FLORIDA DEPARTMENT OF AGRICULTURE AND CONSUMER SERVICES
COMMISSIONER ADAM H. PUTNAM

ADDENDUM 1

TO: Vendors
FROM: Vianka Colin, Purchasing Director
**RE: INVITATION TO BID NUMBER ITB/PI-18/19-18
PURCHASE, DELIVERY AND INSTALLATION OF EMERGENCY GENERATORS**

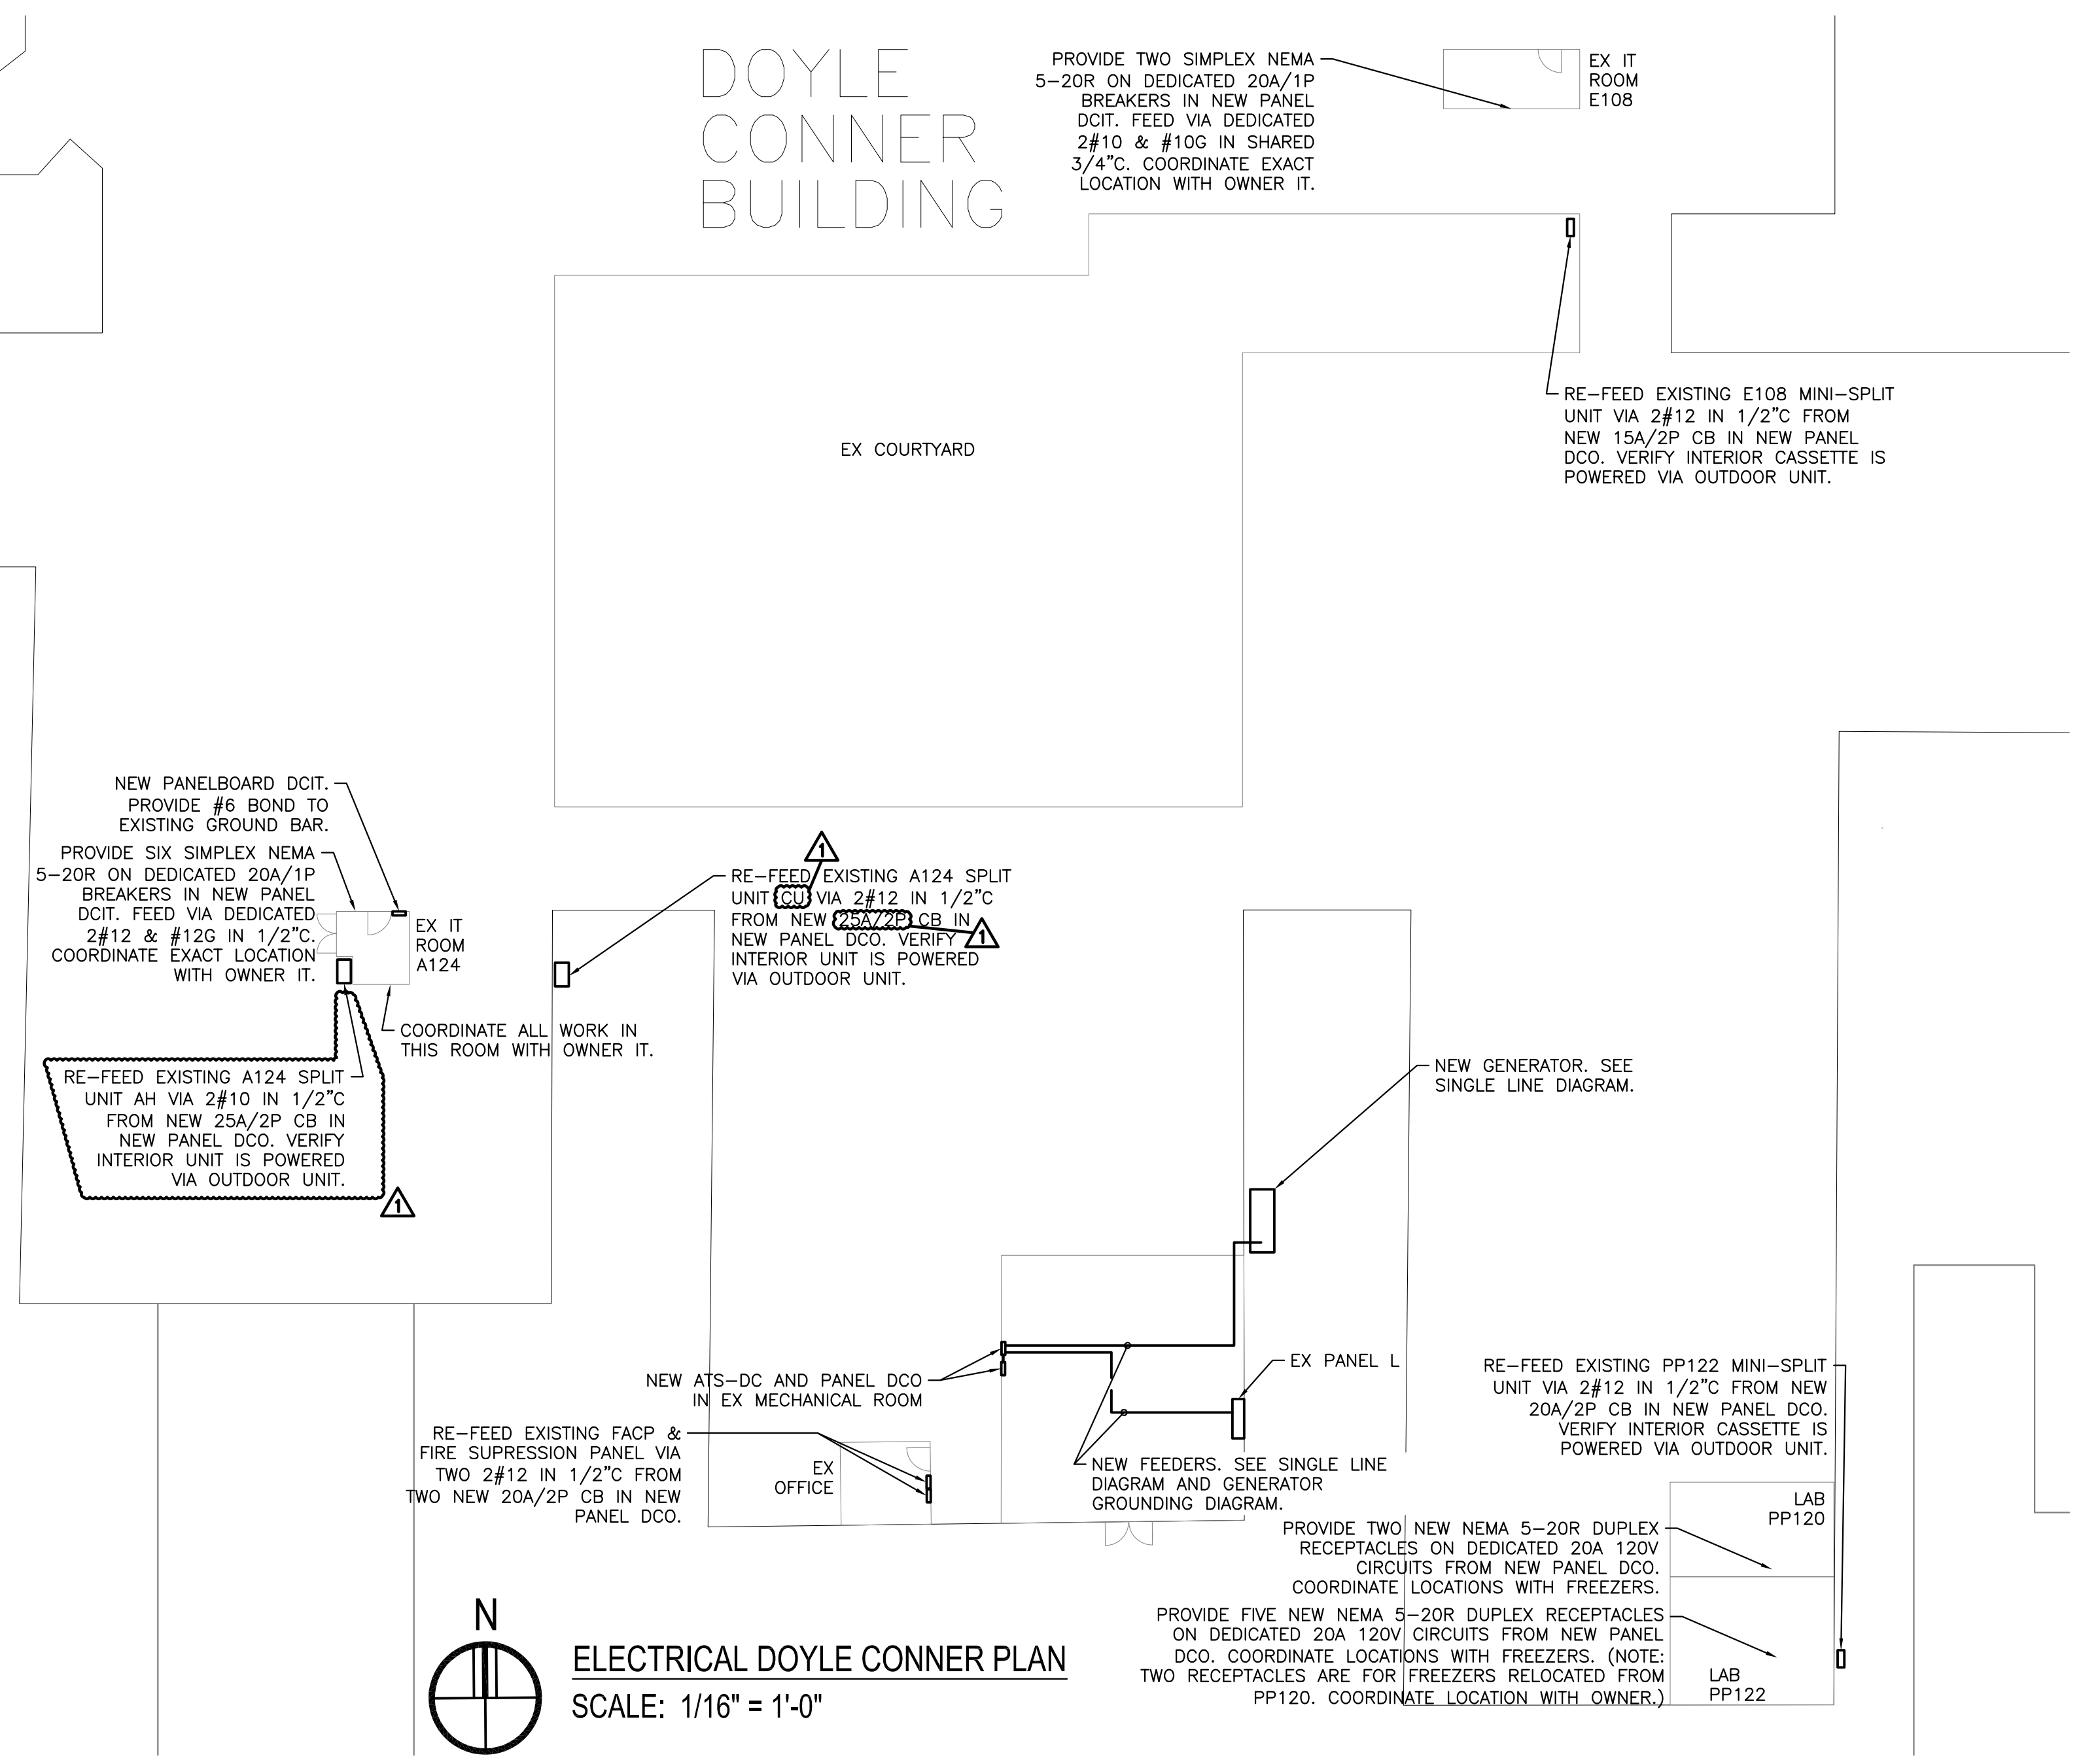
1. ATS for BIO1 shall be moved to the exterior of electrical room wall, just east of the exterior door.
2. The ATS at Doyle Conner building will not need service rating.
3. Doyle Conner Building IT Room A124 will need separate circuits for the air handler and condensing unit.
4. Drawings:
 - a. E2.0 ELECTRICAL BIO 1 PLAN - Replace sheet in its entirety with the attached 24"x36" sheet dated September 10, 2018.
 - b. E2.1 ELECTRICAL PLANT PATHOLOGY PLAN - Replace sheet in its entirety with the attached 24" x 36" sheet dated September 10, 2018.
 - c. E2.3 ELECTRICAL DOYLE CONNER PLAN - Replace sheet in its entirety with the attached 24" x 36" sheet dated September 10, 2018.
